EPC CASE # 2-99-11 DRB CASE # 2000-4-4

Site Plan For Building Permit

PROJECT TITLE: Furr's Supermarket Inc. Golf Course Road and Paseo del Norte Albuquerque, New Mexico

SHEET TITLE: Site Plan

SHEET TITLE
Exterior Elevations

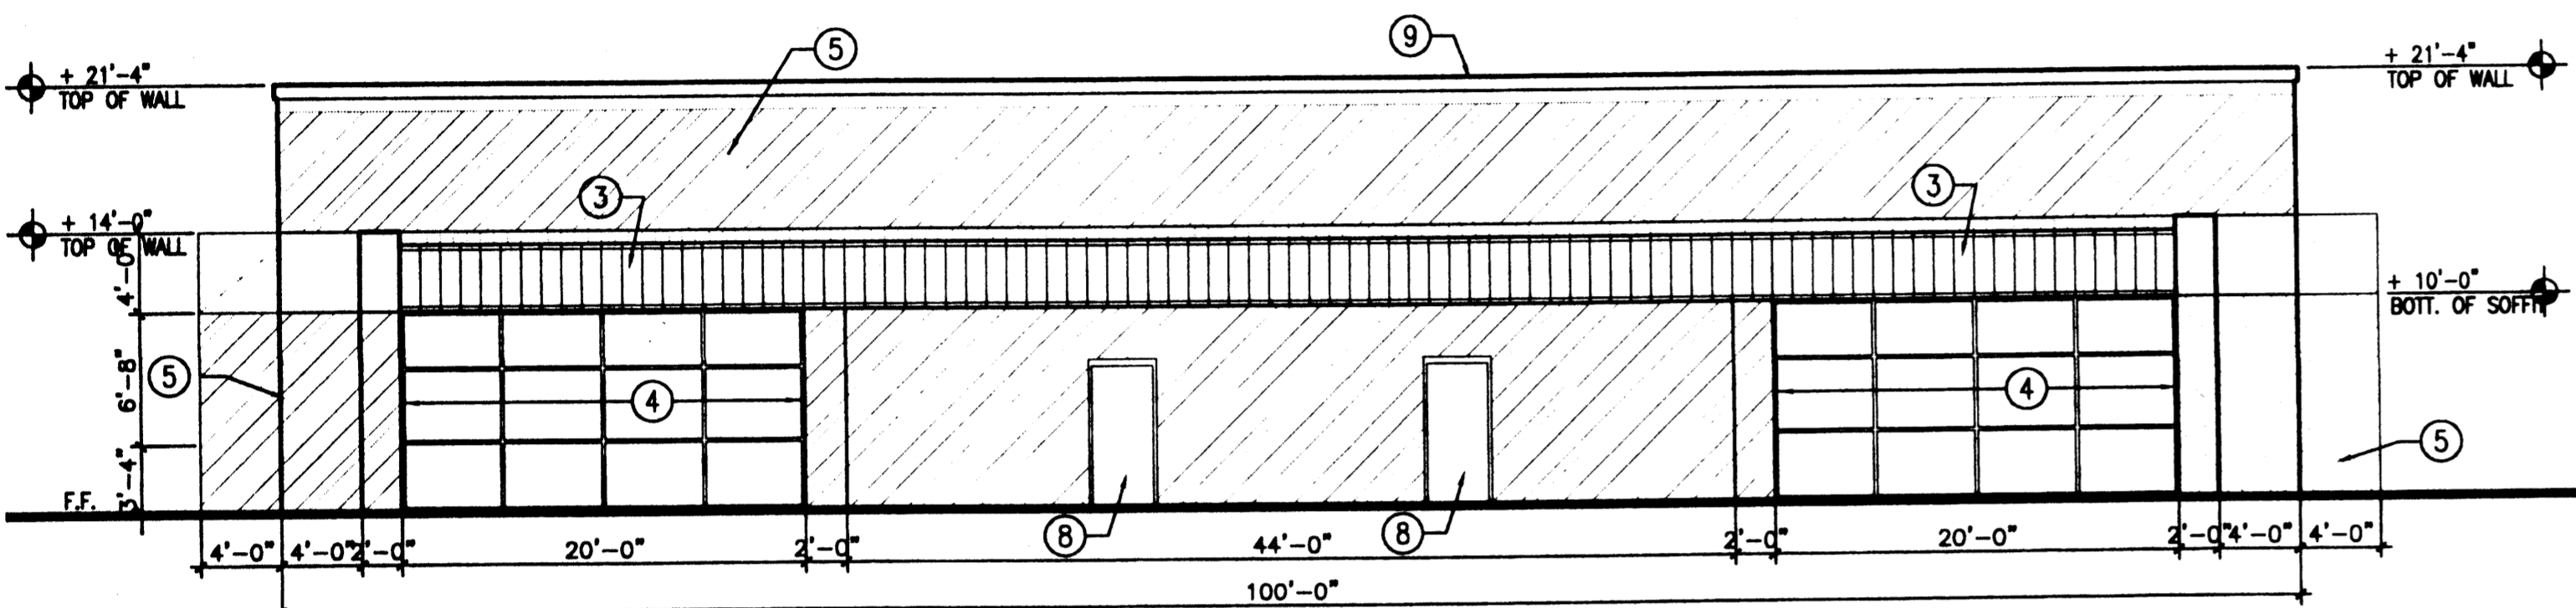
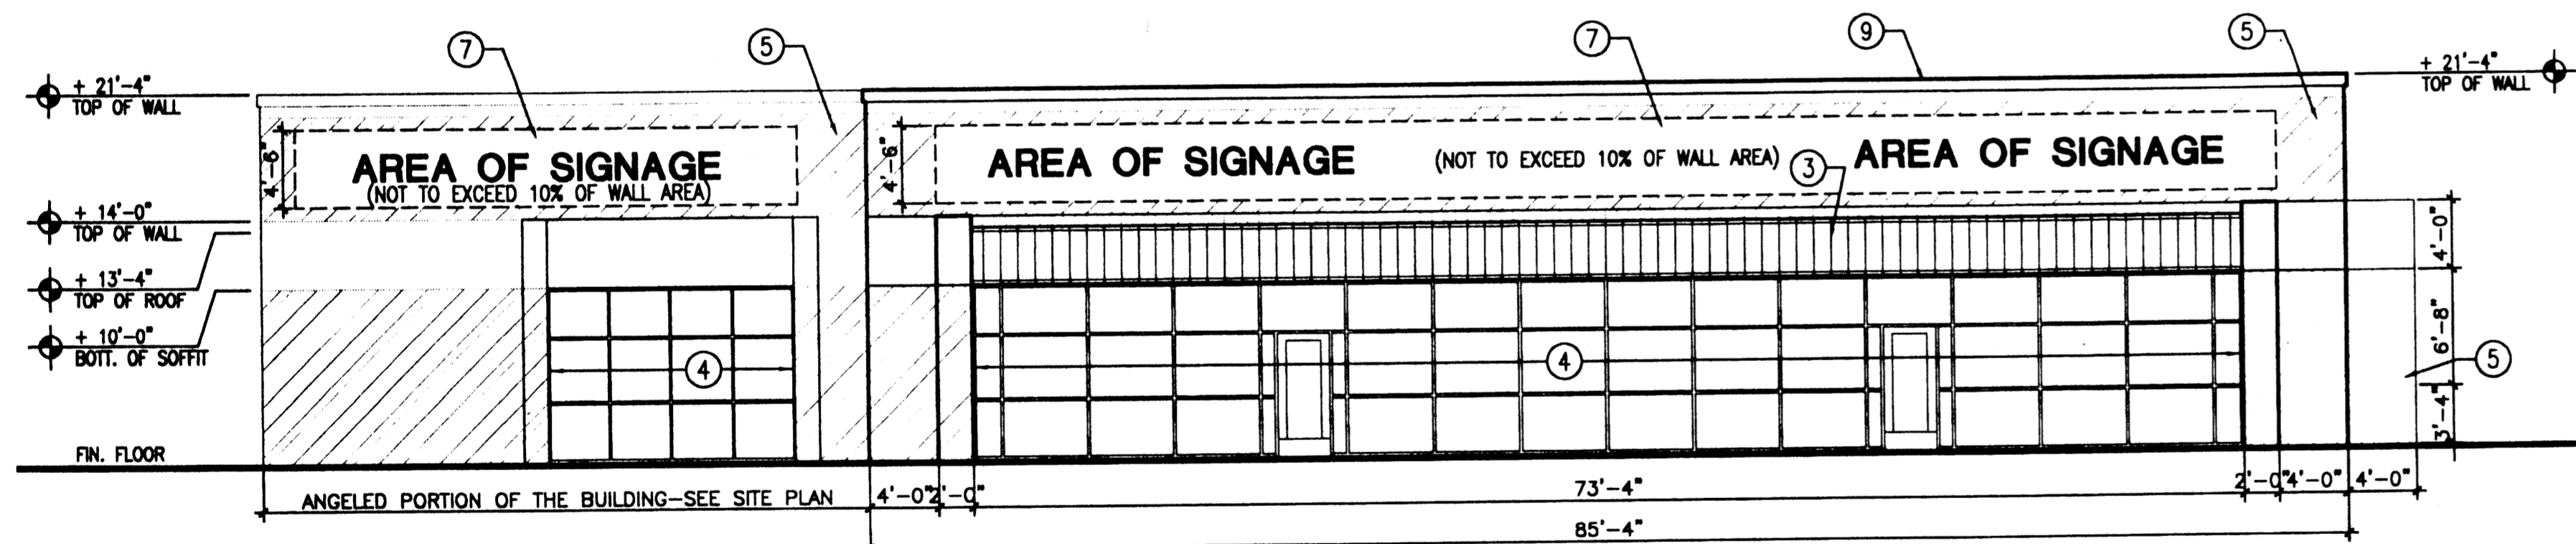
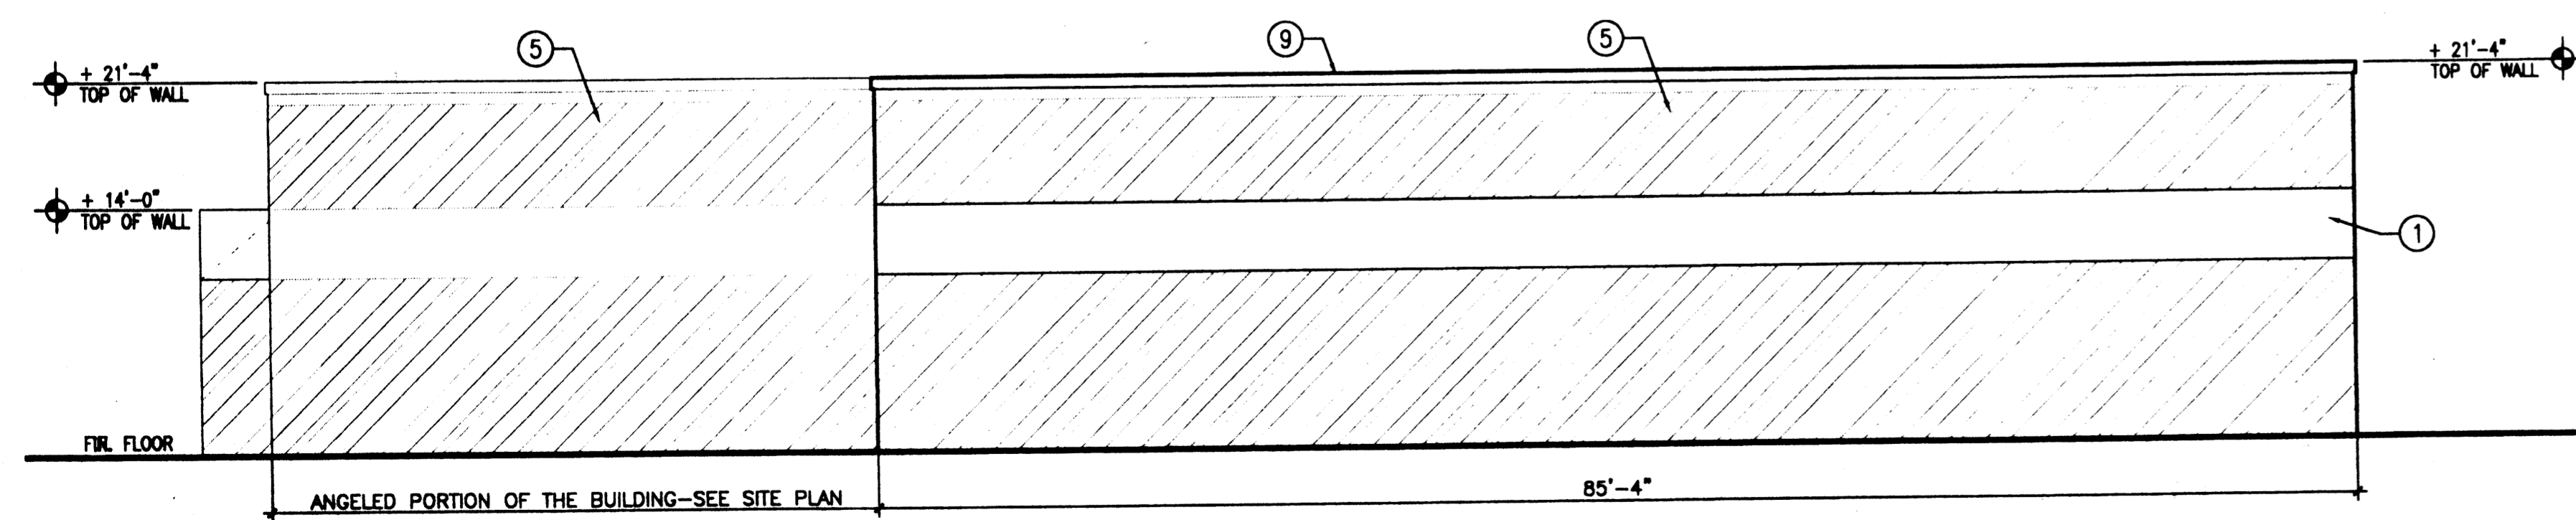
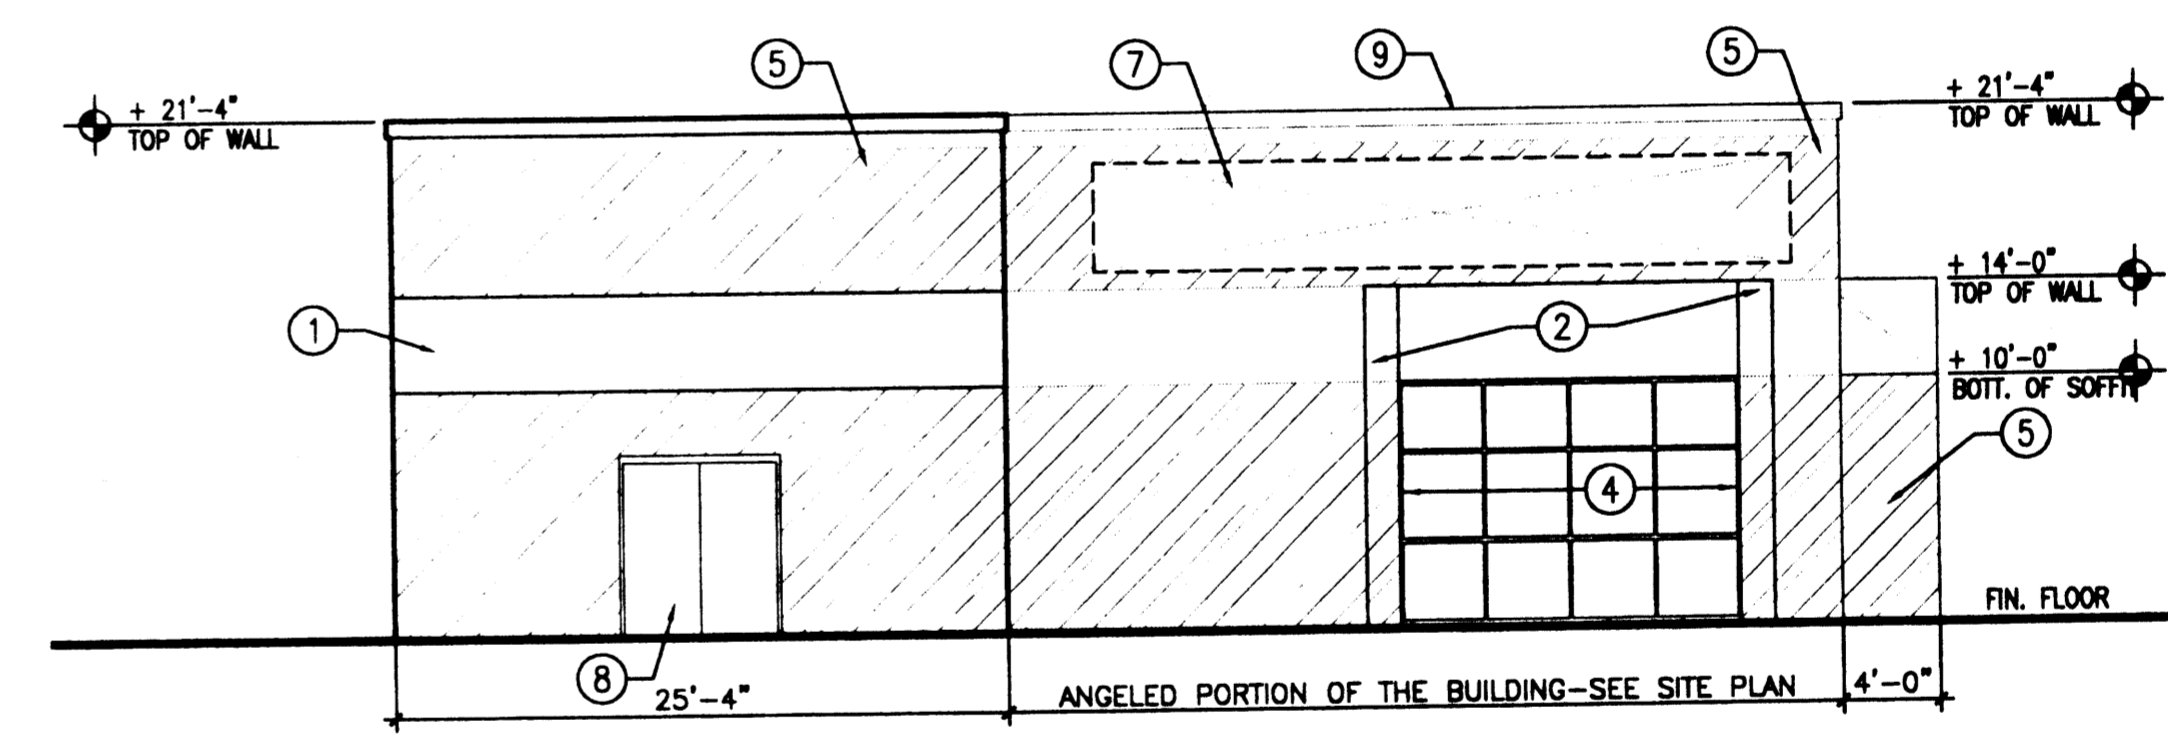
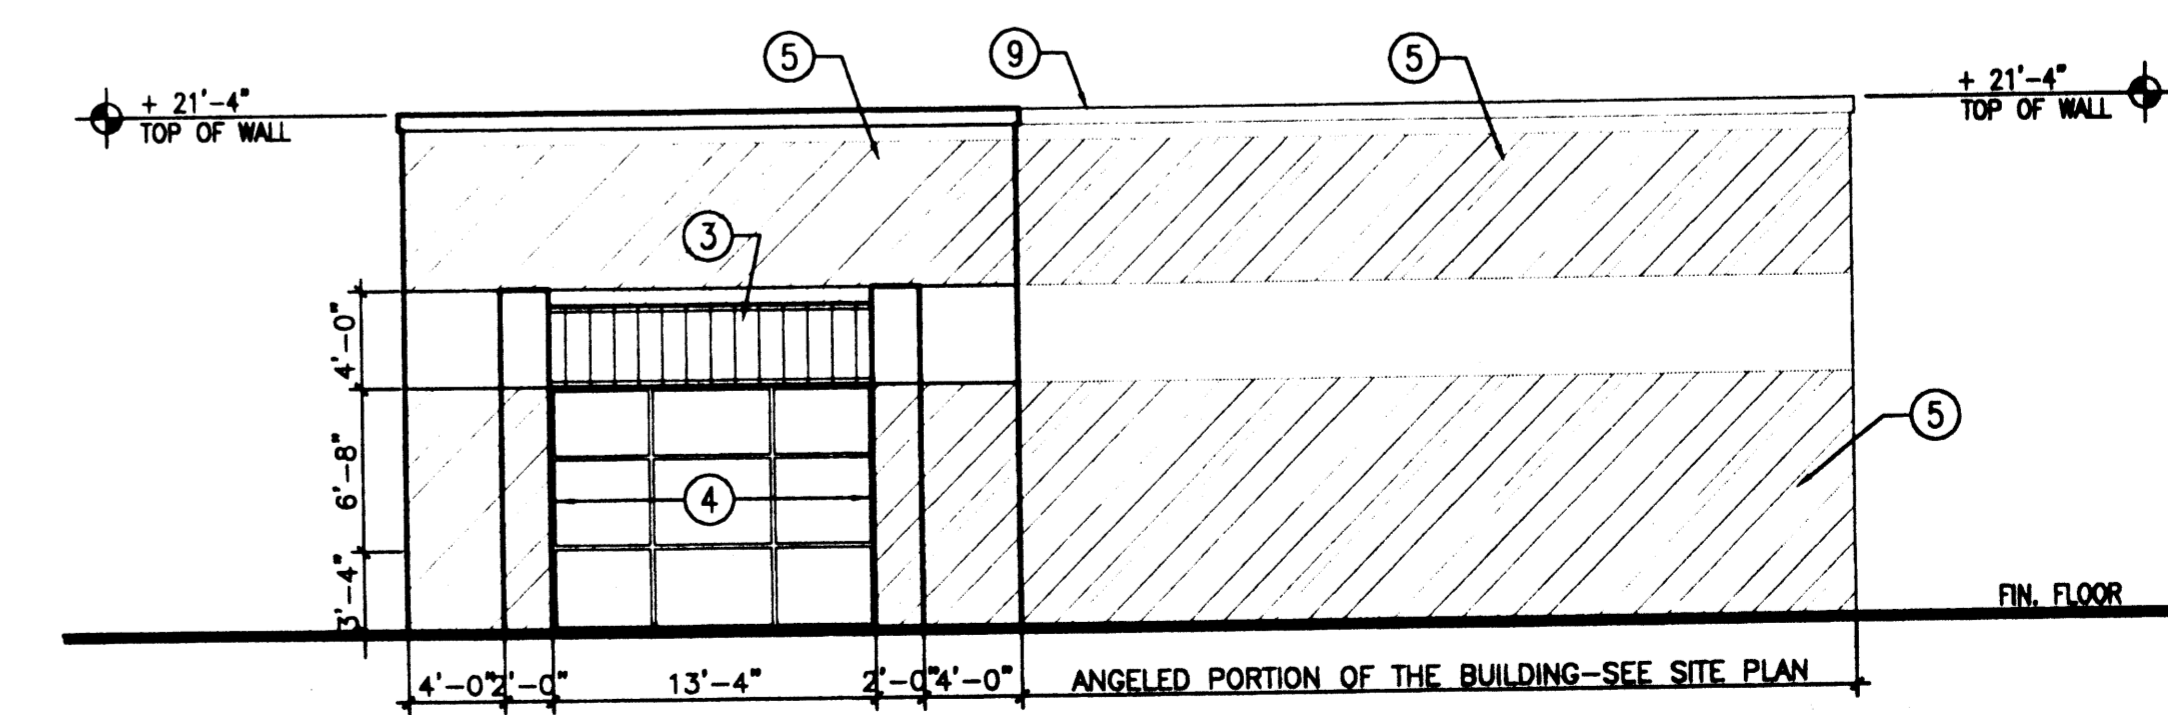
- The following changes shall be made to the site plan, to the satisfaction of the Planning Department, before final DRB sign-off:
 - 70% of the building materials shall be split faced CMU block, as is consistent with the "Pod Architecture Standards."

- A note shall be added to the elevations which indicates that all guidelines of the "Pod Architecture Standards" shall be followed.
 - A note shall be added to the "Pod Architecture Standards" which states vinyl coated plastic reflective type awnings shall not be permitted.

- The following changes shall be made to the elevations, to the satisfaction of the Planning Department, before final DRB sign-off:
 - 70% of the building materials shall be split faced CMU block, as is consistent with the "Pod Architecture Standards."

- A note shall be added to the elevations which indicates that all guidelines of the "Pod Architecture Standards" shall be followed.
 - A note shall be added to the "Pod Architecture Standards" which states vinyl coated plastic reflective type awnings shall not be permitted.

NOTE: ALL GUIDELINES OF PAD ARCHITECTURAL STANDARDS SHALL BE FOLLOWED
